**AMENDMENTS TO THE DRAWING**

**REMARKS****DISCUSSION OF DRAWING**

**FIG. 5**

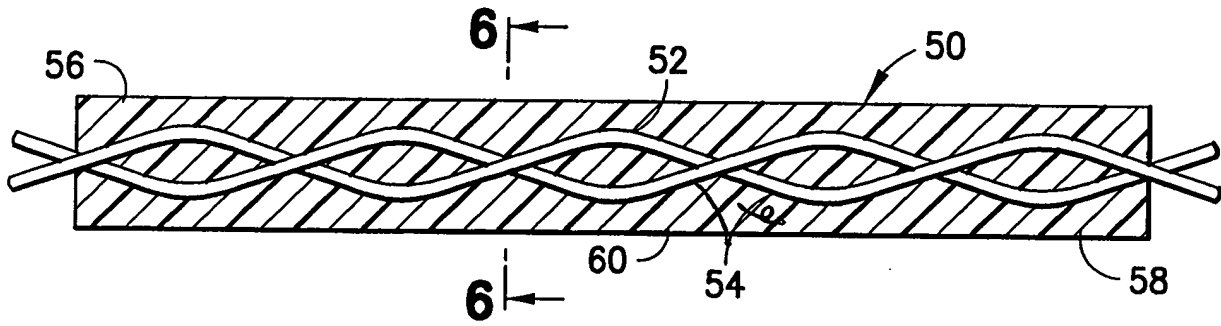
The drawings are objected to because elements 54 and 52 point to the same conductor in Figure 5 and because elements 52A and 54B point to the same conductor in Figure 9. In response thereto, "New Sheets" (Figures 5 and 9) are enclosed herewith in compliance with 37 CFR 1.121(d), wherein elements 54, 52, 52A, and 54B point to different conductors. Furthermore, "Annotated Sheets" are enclosed herewith indicating the changes made to the previous version. Applicants respectfully request acceptance of new Figures 5 and 9.

Enclosed herewith are "New Sheets" (Figures 5 and 9) and which complies with § 1.84.
